Agenda – Council – July 16, 2014

Item No. 4 Secondary Plan – South of Royalwood and Island Lakes, West of Lagimodiere Boulevard and North of Perimeter Highway – Precinct "K"
(St. Boniface Ward)
File SP 3/2014

RE: **Secondary Plan – South of Royalwood and Island Lakes, West of Lagimodiere Boulevard and North of Perimeter Highway – Precinct "K"**
File SP 3/2014

SUBJECT: Precinct (Secondary) Plan for Precinct 'K'

New Figure 1 Land Use and Transportation Concept

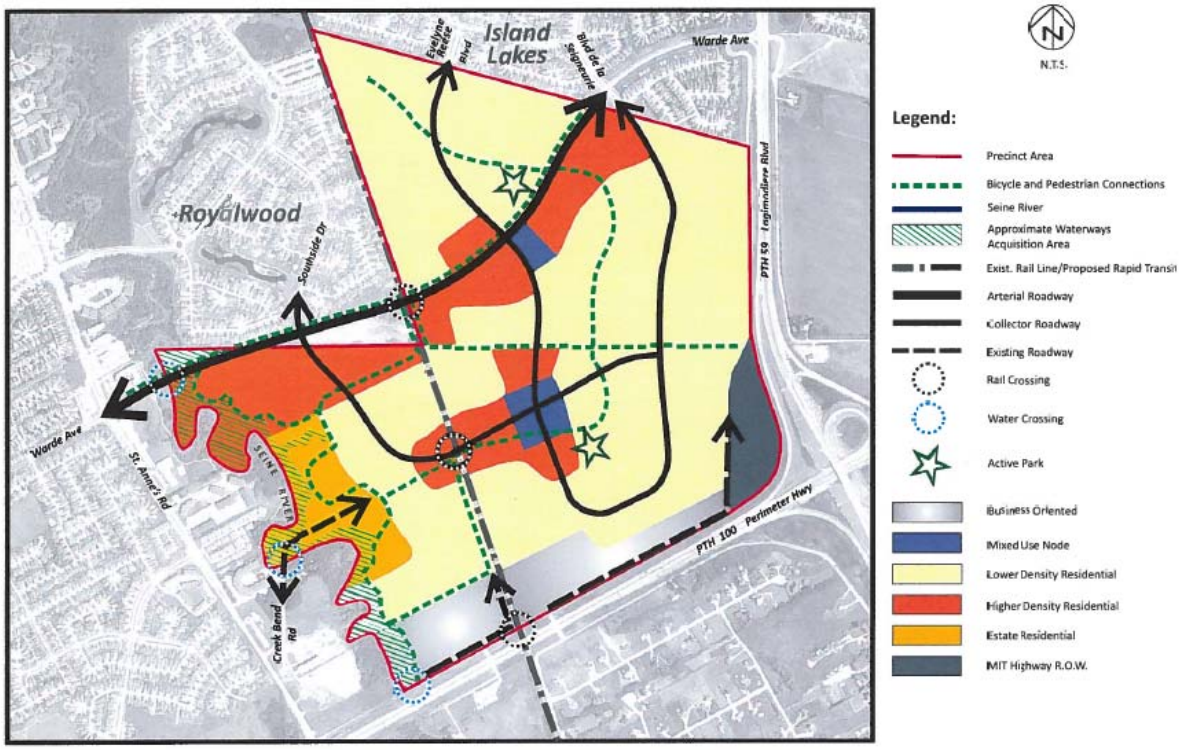
A) That Figure 1 Land Use and Transportation Concept be deleted, and replaced with the new Figure 1 Land Use and Transportation Concept, included as Appendix B.

D) Reference to the 'MIT Control Zone' as it appears on Figure 1, be altered to read: MIT Highway ROW

Figure 2: Representation of Existing Roads

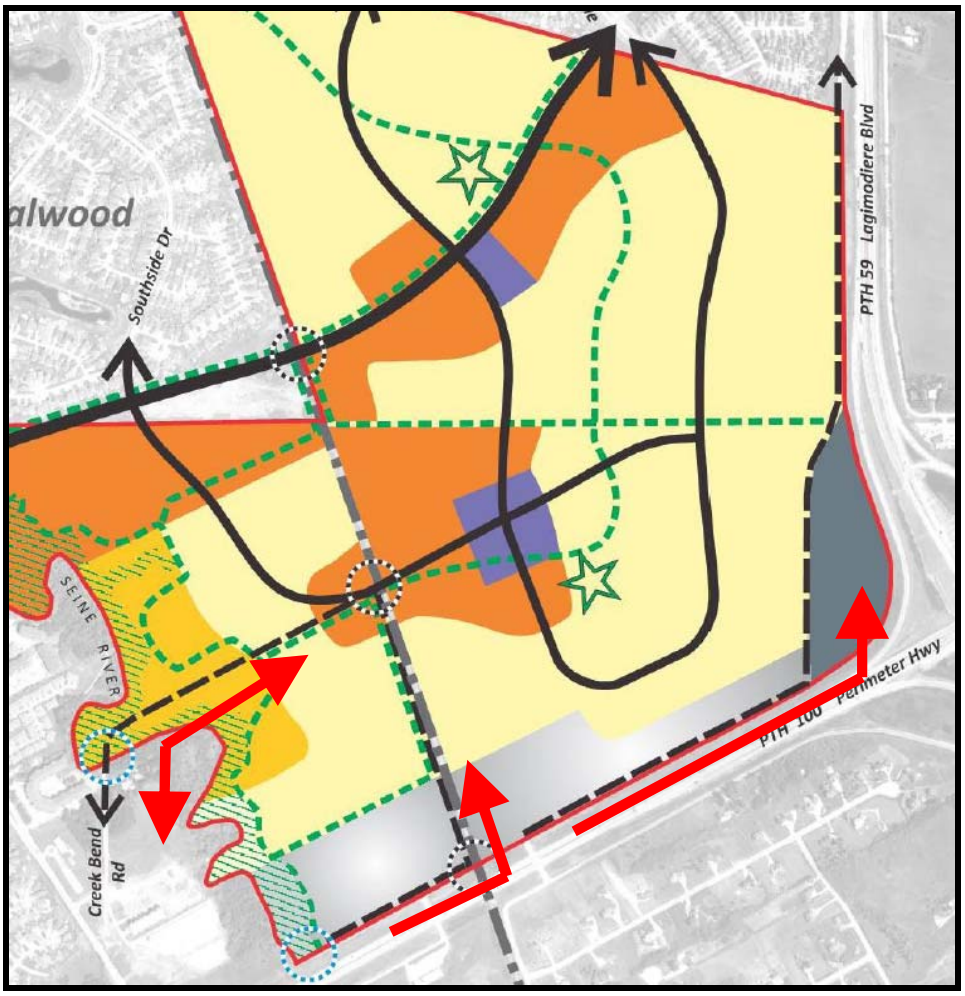
C) The existing roads represented as dashed black lines on the map included as Figure 1 'Land Use and Transportation Concept' be shortened in accordance with the thick red arrows as depicted on Figure 2: 'Representation of Existing Roads' as included in Appendix 'A' (of this report)

- Melnick Road and Aimes Road currently have access to the Perimeter Highway with secondary access through the Plan area. The Province has indicated that access to the Perimeter Highway will be eliminated in the future. With access to the Perimeter Highway severed, the existing businesses along Aimes Road and Melnick Road will have to rely on access through the Plan area.

- In addition, Figure 1 should be altered so as not to imply that Melnick Road will exist in the future as part of this Plan. For the purposes of clarity, it is recommended that the existing roads represented as dashed black lines on the map included as Figure 1 'Land Use and Transportation Concept' be shortened in accordance with the thick red arrows as depicted on Figure 2:'Representation of Existing Roads' of this document.

b) The existing roads represented as dashed black lines on the map included as Figure 1 'Land Use and Transportation Concept' be shortened in accordance with the thick red arrows as depicted on Figure 2:'Representation of Existing Roads' of this document
